# Frisco to Breckenridge

## State Highway 9 Record of Decision

**State Highway 9  
Frisco to Breckenridge  
Summit County, Colorado**

**STA 009A-021  
FHWA-CO-EIS-02-01-F**

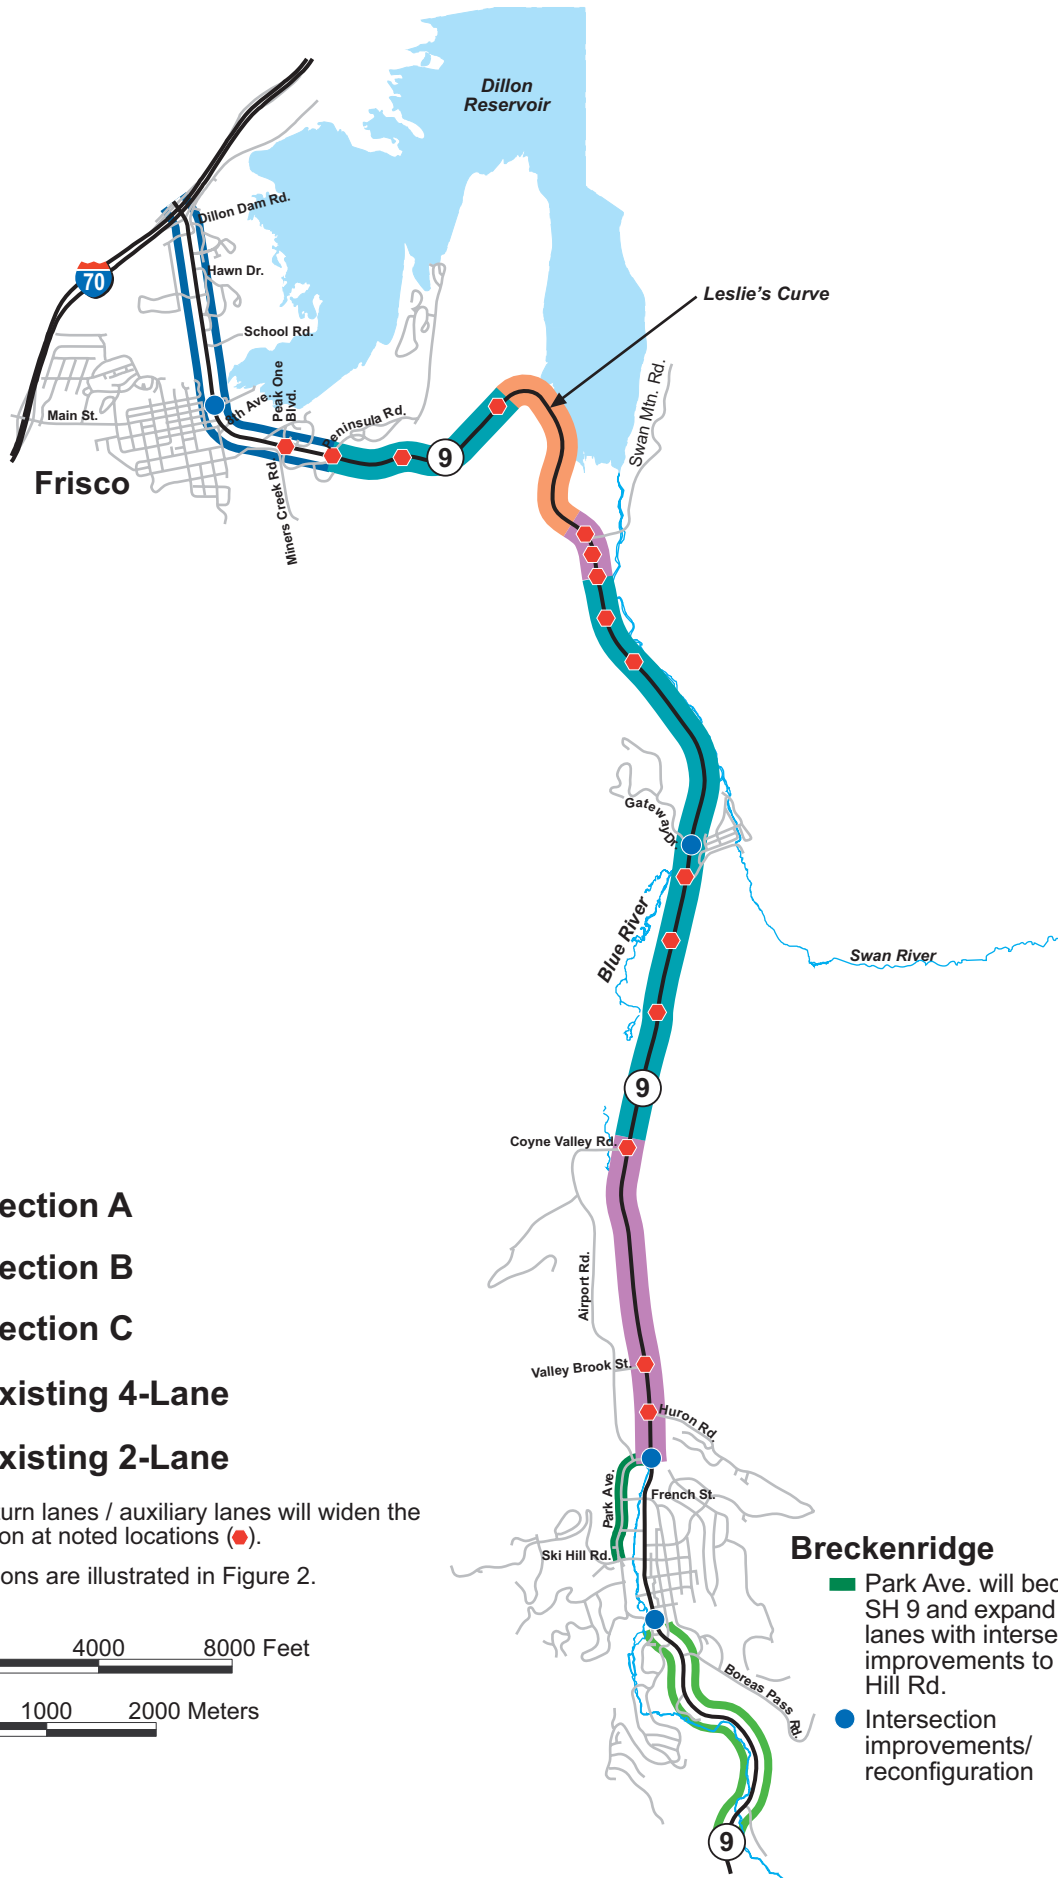
- 15b • Figure 1-3, **Preferred Alternative Layout**, shows an existing 4-lane section in the Town of Frisco from Miners Creek Road to Peninsula Road. The existing 4-lane section through Frisco ends at Miners Creek Road. The existing section between Miners Creek Road and Peninsula Road is a single lane in each direction with either acceleration or deceleration lanes on each side. The Town thought that Typical Section B was to be used between the two intersections. At previous Aesthetic meetings for the EIS, the Town had supplied details of treatments to be used in the medians.

- 15a: Correct. Alternative 1 would be safer. The intent of the sentence in the FEIS is that safety is improved to an acceptable level with Alternative 3 compared to the other build alternatives. The meaning was that the wider median alternatives (1 and 2) were safer, but Alternative 3 still improved safety, while Alternative 4 improved safety the least.
- 15b: These will be incorporated into the final design process per *SH 9 Aesthetic Study and Design Guidelines* prepared by CDOT.
